# ***Casuarina Town Centre***

*Modification Assessment  
(MP 06\_0258 MOD 10)*

September 2018

Figure 6: Proposed staging (lots to be developed in Stage 2 outlined in yellow)

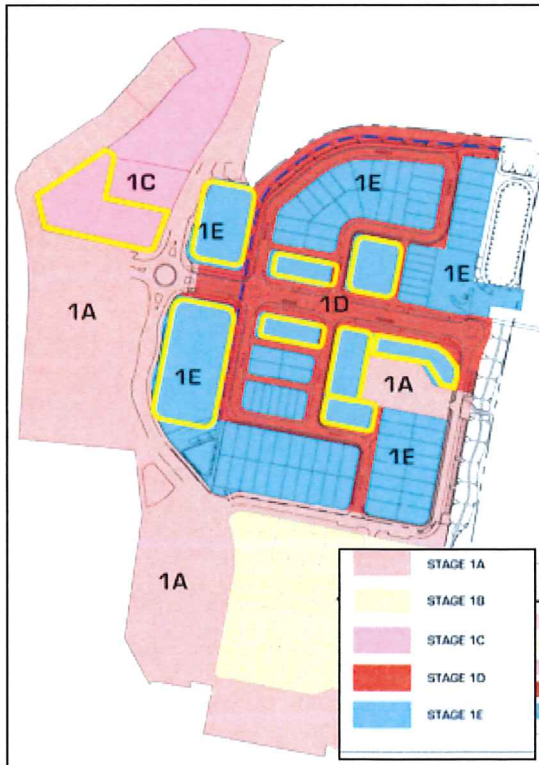
Council has advised it does not object to the proposed sub-staging of Stage 1 provided the provision of infrastructure (Stage 1D) occurs prior to the release of allotments (Stage 1E). DPI also advised it has no objection to the proposed modifications.

The Department agrees with Council that all infrastructure works should be provided prior to the release of the residential allotments. However, the staging plans indicate the construction, embellishment and dedication of the two public reserves would be undertaken in the same sub-stage as the release of the residential lots, rather than prior to their release. This differs from the current approved staging which requires delivery of the parks prior to any residential development in this part of the site.

The Department considers the parks and open space provide valuable amenity for future residents. As such, the parks and open space should be provided prior to the release of the residential lots. A condition has therefore been recommended requiring all infrastructure, including the public reserves to be provided prior to the release of any lots in Stage 1E.

Figure 11: Approved (top) and proposed (bottom) section through green buffer / drainage reserve

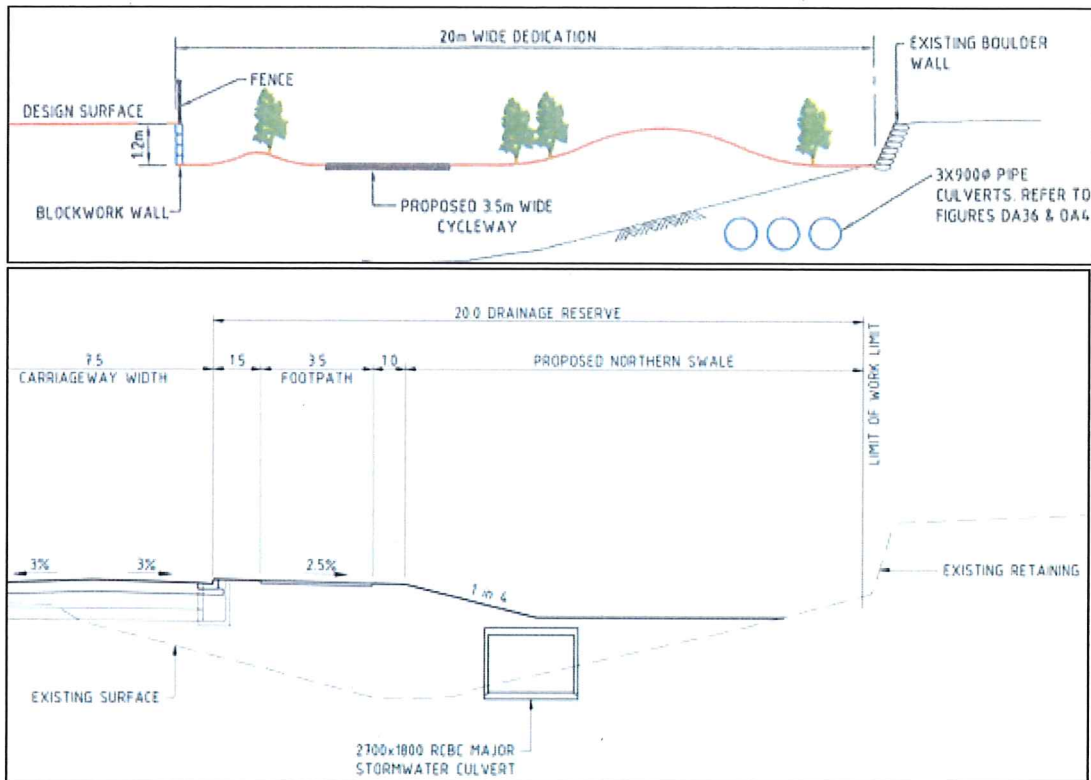
Design of Green Buffer	<ul style="list-style-type: none"> <li>The approved development includes piping of an existing drainage swale along the northern boundary and the creation of a 20 m wide landscaped corridor (including a 3.5 m wide cycleway) over the piped infrastructure for the length of the drainage reserve. The approved landscape plans (under MOD 1) incorporates dense shade tree planting for the length of the corridor, providing privacy and visual screening for neighbours to the north.</li> <li>The modification initially sought to incorporate a roadway into the corridor, resulting in a reduced 8 m wide landscaped buffer and cycleway. However, following a large number of submissions objecting to the reduced buffer, the 20 m wide buffer with cycle path was reinstated in the RTS.</li> <li>The Department notes, the proposed landscape plans only indicate shrub and groundcover plantings within the corridor, and do not indicate the dense shade tree planting currently approved.</li> <li>The Department considers the corridor should be planted with shade trees consistent with the existing approval to provide privacy and visual screening for adjoining dwellings and to provide shade and amenity along the shared path. It is therefore recommended that a condition be included accordingly.</li> </ul>	A condition is recommended to be updated to require tree planting along the northern green buffer consistent with the exiting approval.

**Figure 13:** Extract from Proponent’s Town Centre Vision and Landscape Document.

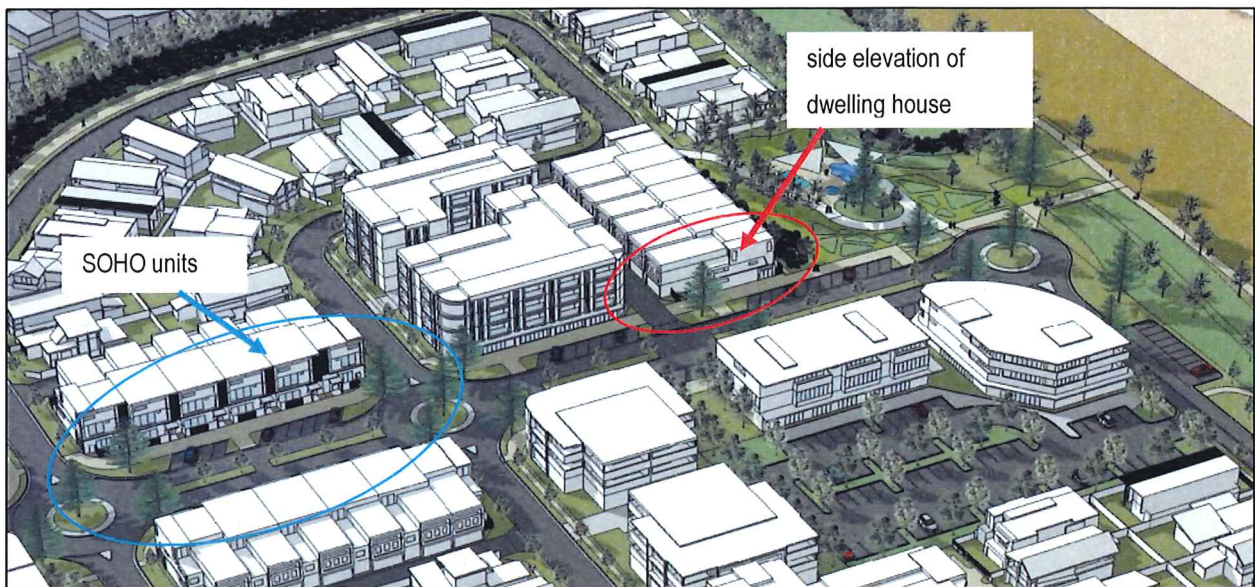
While the Department considers the proposed building heights are acceptable, it raises concern about the bulk and scale of the three and four storey building envelopes on the site as they have been designed with minimal building separation and setbacks. The Department also notes the four-storey building envelope in the north-west corner of the site has been designed as one continuous building, occupying most of the site (see **Figure 12**).

The Department notes both commercial uses and home offices are permissible on the site, and therefore, it is not necessary to define the future land uses. However, the Department considers it is important that any future development, whether shop top housing, SOHO or other form of mixed use development, presents an active commercial or retail frontage to Grande Parade to contribute to the character of the village centre. The Department has therefore recommended a future assessment requirement requiring active frontages to be provided for the length of Grand Parade from Road B to the foreshore.

To address this issue, the Department recommends a modification to the Concept Plan Approval clarifying that:

- the future built forms shown in the concept plans are only approved to the extent that they indicate the location of where three and four storey building envelopes can be developed
- the GFA of the proposed building envelopes shown in the plans is not approved as the buildings will be subject to further design refinement as part of the assessment of future development applications.

**Figure 14:** Proposed Road Layout. New northern road shown in blue and location of median extension to prevent right and u turns shown in red (source: Proponent's RTS)

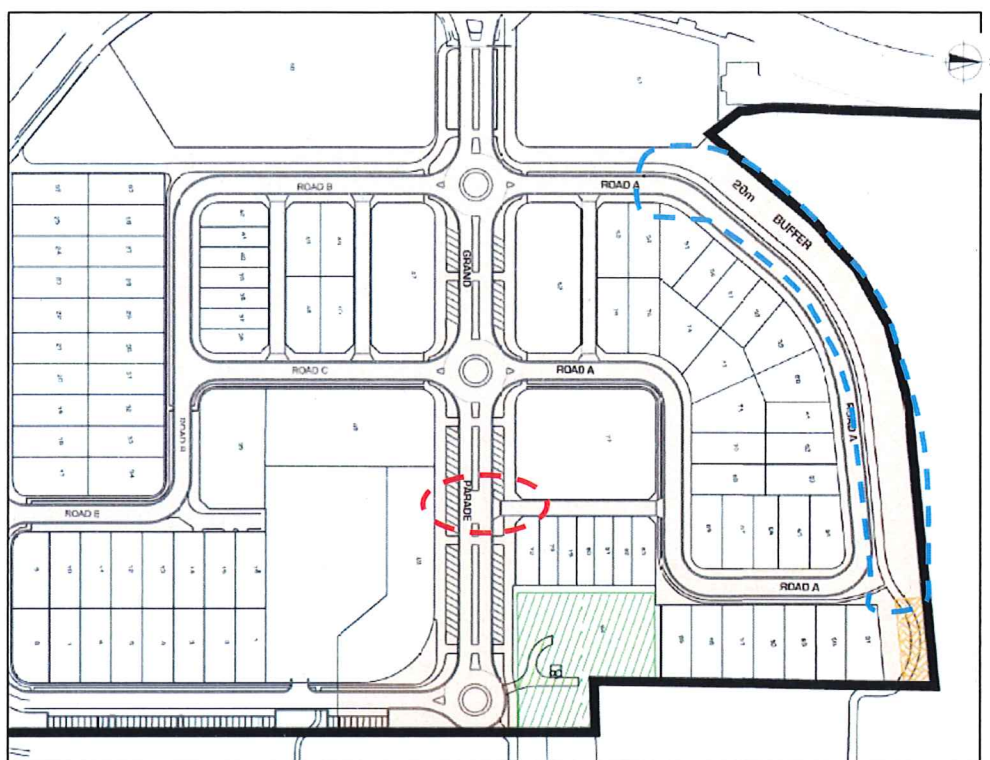
Public submissions raised concerns about the new northern road in proximity to adjoining dwellings to the north of the site and the potential for the road to cause adverse noise and light spill impacts. Public submissions also suggested the main street should include an open area or pedestrian plaza to improve the amenity and character of the area.

Council advises its initial concerns with the road layout have largely been resolved in the RTS, but suggested minor modifications, including an extension of a median on Grand Parade to prevent right-hand and u-turns (shown in **Figure 14**) and confirmation that new laneways will be designed to Council’s standards.

In response to concerns raised about potential amenity impacts associated with the alignment of the northern road, the Proponent submitted an acoustic report which demonstrates traffic noise from the road would be well within accepted criteria. The Department also notes Condition B35 of the Project Approval requires lighting to be approved by Council and designed so it would not adversely impact on the surrounding residential development. In addition, the 20 m road corridor would provide adequate separation between the local road and adjoining residents to appropriately minimise noise and light spill impacts. The Department is therefore satisfied the alignment of the new northern road would not result in any significant amenity impacts on nearby residents.

The Department agrees with Council, that extending the median along Grand Parade would result in safer traffic environment, and less potential for vehicle and pedestrian conflicts in this section of the street. A condition has therefore been recommended to extend the median. A condition is also recommended requiring the laneways to be designed to Council's standards, with detailed plans of all roads to be approved by Council prior to the relevant construction certificate.
